Shop Drawing Submittal Review

Project Name: Webster University-**ISB**

Copies	No.	Description
1 PDF	224216P02	(Submittal No.'s)
		(Cannon #22 4216.16-001) - (Paric #15051-) - (WES #607)
		➤ Commercial Sinks
		• Clinical Service Sink CSS-1
		• Scrub Sink SS-1
		• Sink SK-1
		• Garbage Disposer GD-1
		• Sink SK-2
		• Sink SK-3
		• Mop Sink MS-1
		• Kitchen Sinks KS-1, KS-2, KS-3

SPEC SECTION: 22 4216.16
Commercial Sinks

SK-3

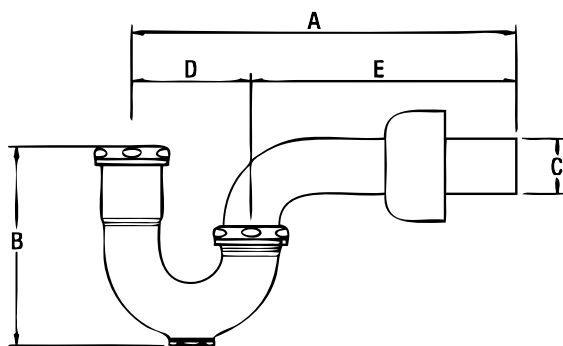
S/S SINK BASKET STRAINER W/ 1-1/2" CP BRASS TAILPIECE
1-1/2 SEMI CAST P TRAP W/CO CP
LF 1/2" NOM COMP X 3/8" OD COMP W/ LOOSE KEY
12" X 3/8" OD LAVATORY SUPPLY LINE
5/8" OD CP SHALLOW ESC FLANGE
~~COVER FOR TRAP / HOT & COLD STOP & SUPPLY~~
~~LEAD LAW COMPLIANT 3/8 THERMOSTAT TEMPERING VALVE~~

1. Sink is integral with the counter-top. Coordinate with the architectural drawings.
2. Provide under counter waste and supply protective piping covers as required.
Verify requirements with the architectural drawings.
3. Escutcheons are specified to be cast brass. Refer to specification section 220518.
